Road Infrastructure Design Report

Strategic Housing Development

**Clonkeen College, Clonkeen Road,
Blackrock, Co. Dublin**

This report was prepared in response to a request from Mr Gordon Finn of Cronin & Sutton Consulting to provide a Quality Audit for the Proposed Residential Development at Clonkeen College, Co. Dublin. The Quality Audit shall consider the following elements:

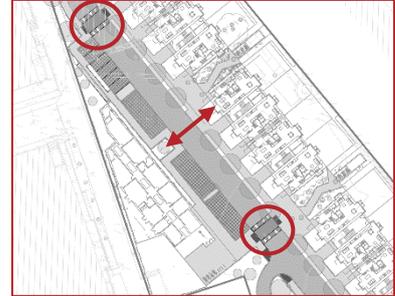
Information regarding the swept path of large vehicles (refuse trucks, emergency vehicles, delivery vehicles etc.) has not been provided to the Audit Team. It is therefore unclear if these vehicles will have sufficient space within the development at horizontal curves, when undertaking u-turns, and when traversing the set down areas proposed, without crossing over into the opposing traffic lane, mounting footpaths or colliding with roadside furniture. If sufficient space is not available for large vehicles to travel, and turn safely within the development, this could lead to these vehicles having to reverse back through the development when exiting which could lead to an increased risk of collisions with other vehicles or VRUs.

Ensure the internal road network within the development can accommodate the swept path of large vehicles.

Location: Drawing W012-CSC-ZZ-XX-DR-C-0026

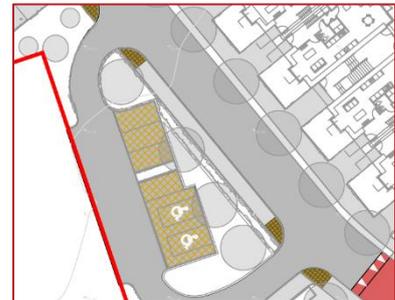
Drivers approaching this location may be less attentive to pedestrians crossing the carriageway away from the formal crossing points leading to reduced reaction time and an increased risk of collisions with pedestrians.

An uncontrolled crossing, with dropped kerbs and appropriate tactile paving, should be provided at the gap indicated in the proposed parking provision.

Location: Drawing W012-CSC-ZZ-XX-DR-C-0026

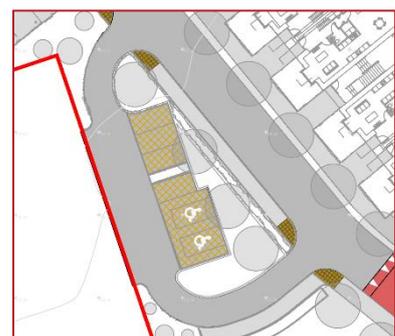
A row of parking spaces, including two mobility impaired spaces, has been indicated to the north of the first apartment block within the proposed development. A link to the proposed footpath has not been indicated at this location resulting in vehicle occupants, including the mobility impaired, having to enter the carriageway or adjacent verge after exiting their vehicle where there is an increased risk of being struck by a vehicle or slips and falls respectively.

A footpath should be provided adjacent the parking spaces and a link/formal crossing provided so that vehicle occupants can access the surrounding footpath network.

Location: Drawing W012-CSC-ZZ-XX-DR-C-0026

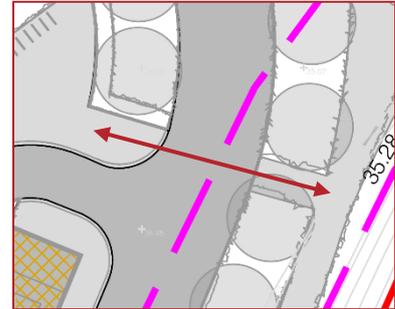
Access/egress to/from a set down area has been indicated to the south of the first apartment block within the proposed development. Parking spaces have been indicated within the 'island' created by the entry and exit with a footpath indicated in front of the parking spaces. Pedestrian crossings, including dropped kerbs and tactile paving, have however not been indicated across the entry/exit providing access from the island parking to the footpaths north and south of the set down area. This could lead to mobility impaired drivers/passengers experiencing difficulty when accessing the footpaths adjacent the apartment blocks increasing the risk of trips and falls should they attempt to descend high kerbs.

Provide uncontrolled pedestrian crossings, including dropped kerbs and tactile paving, across the entry/exit to the set down area at this location.

Location: General Problem - Drawing W012-CSC-ZZ-XX-DR-C-0026

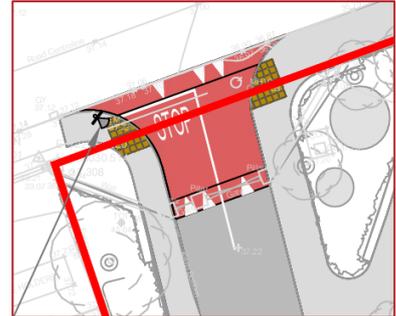
Trees have been indicated adjacent pedestrian crossings throughout the proposed development. This could lead to the inter-visibility between pedestrians and drivers at crossings being restricted which could lead to drivers failing to slow down, or stop, when approaching, or at, crossings resulting in vehicle pedestrian collisions.

Ensure trees adjacent pedestrian crossings do not restrict inter-visibility between road users.

Location: Drawing W012-CSC-ZZ-XX-DR-C-0026

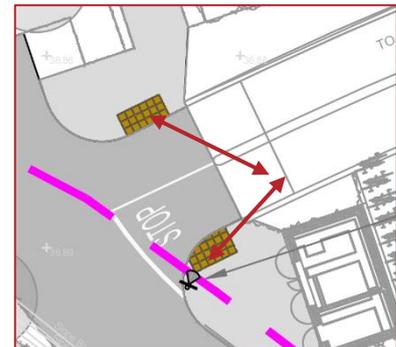
The Stop line at the proposed development access has been indicated on the proposed raised-table ramp crossing. This could lead to side road drivers entering the raised-table crossing without due care and consideration for approaching pedestrians increasing the risk of vehicle-pedestrian collisions.

The Stop line should be provided on the carriageway upstream of the ramp so that drivers are required to stop before entering the crossing, increasing their awareness to approaching pedestrians, before slowly moving forward and pausing again before entering the major road.

Location: Drawing W012-CSC-ZZ-XX-DR-C-0026

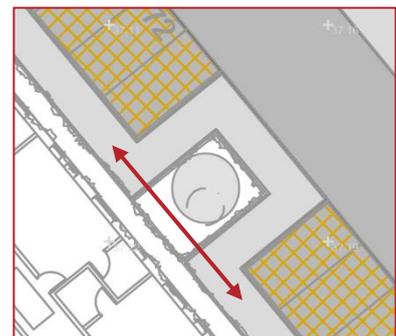
An uncontrolled pedestrian crossing has been indicated across the entry/exit to/from the basement carpark. It is unclear if sufficient inter-visibility will be achievable between drivers exiting the basement and pedestrians waiting at the pedestrian crossing due to the ramp walls at this location, as details of the wall (i.e. height) have not been indicated. Should pedestrians have insufficient visibility towards a vehicle ascending the ramp, there is a risk that they may commence a crossing ahead of an approaching vehicle whose driver may have insufficient time to react safely, increasing the risk of vehicle-pedestrian collisions.

Ensure sufficient inter-visibility is provided between drivers ascending the basement carpark access ramp and pedestrians waiting at the uncontrolled crossing at this location.

Location: Drawing W012-CSC-ZZ-XX-DR-C-0026

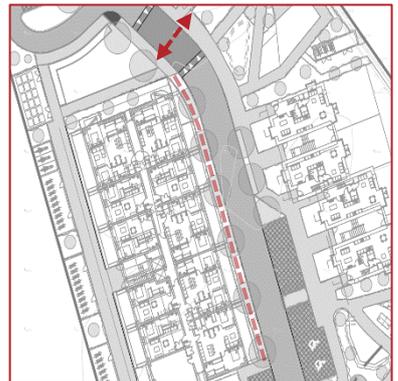
If safe access is not provided close to the sheltered bicycle parking facilities, there is a risk of cyclists falling from their bicycle as they mount high kerbs or having to travel in narrower sections of footpath with pedestrians from dropped kerb accesses increasing the risk of conflicts between pedestrians and cyclists.

Ensure safe access for cyclists, via dropped kerbs, is provided close to bicycle parking facilities and that the routes to/from the cycle parking facilities are sufficiently wide to safely accommodate both pedestrians and cyclists.

Location: Drawing W012-CSC-ZZ-XX-DR-C-0026

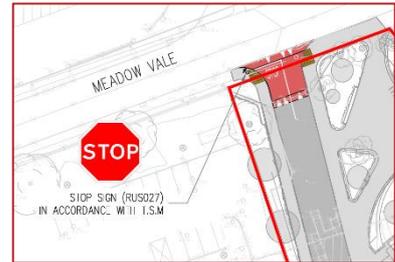
This could lead to visually, and mobility, impaired pedestrians being unable to safely and independently navigate the road layout and being stranded within the footpath at this location. Pedestrians may continue within the verge where there is an increased risk of trips and falls or cross the carriageway to the opposing footpath where there is an increased risk of being struck by a vehicle should drivers be less attentive to pedestrians crossing away from formal crossing points.

A footpath should be provided in front of the apartment building linking the footpaths proposed at either end or a formal pedestrian crossing provided at this location to allow pedestrians to cross to the eastern side of the carriageway and continue their journey.

Location: Drawing W012-CSC-ZZ-XX-DR-C-0026

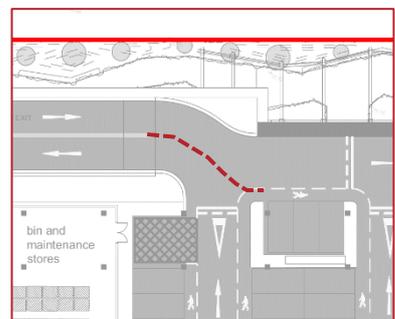
Hazard tactile paving has not been indicated at the top and bottom of steps within the proposed development. This may lead to visually impaired pedestrians being insufficiently aware that they are approaching a flight of steps increasing the risk of slips, trips, and falls should visually impaired pedestrians continue toward the vertical hazard without due care and attention.

Corduroy hazard tactile paving should be provided at the top and bottom of all flights of steps within the proposed development.

Location: Drawing W012-CSC-ZZ-XX-DR-C-0027

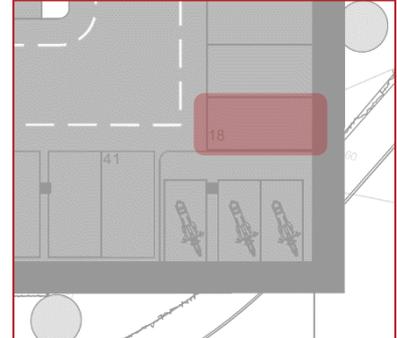
At the bottom of the basement carpark access ramp drivers entering the carpark must proceed straight ahead while drivers exiting the westernmost aisle of parking spaces can turn left to exit the carpark or right to proceed back through the carpark. Lane guidance markings have not been indicated at the bottom of the ramp to guide drivers into the correct lane when entering the carpark. This could lead to drivers encroaching into the opposing lane and possible head-on, or side swipe, collisions with vehicles exiting the carpark.

Measures should be provided to guide drivers entering the carpark into the correct lane.

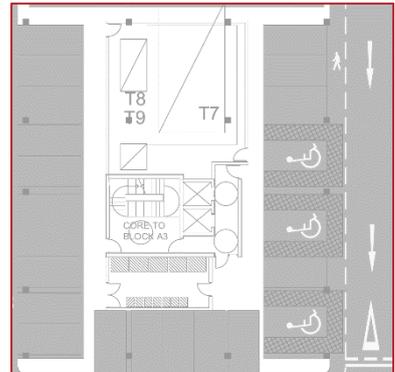
On the eastern side of Clonkeen Road the footpath on the northern side of Meadow Vale should be extended through the junction corner radii as far as the signalised crossing and a full height kerb provided where the stem of the tactile paving terminates.

On the western side of the crossing the stem of the tactile paving should terminate at the location where the footpath changes direction. Buff coloured tactile paving, 1.2m deep, should be provided at the existing dropped kerb and a new dropped kerb provided on the other side of the service road with a similar tactile paving arrangement, ensuring the dropped kerbs and tactile paving are aligned.

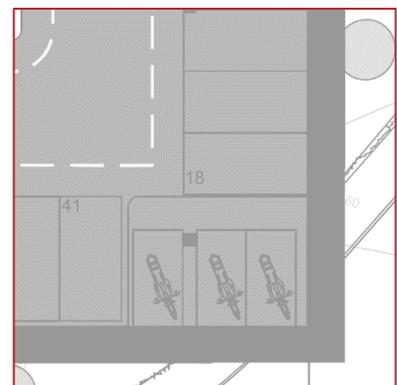
Ensure a refuse strategy is developed clearly explaining how refuse is to be transported, and collected, and how refuse vehicles are to access the bin stores/collection points.
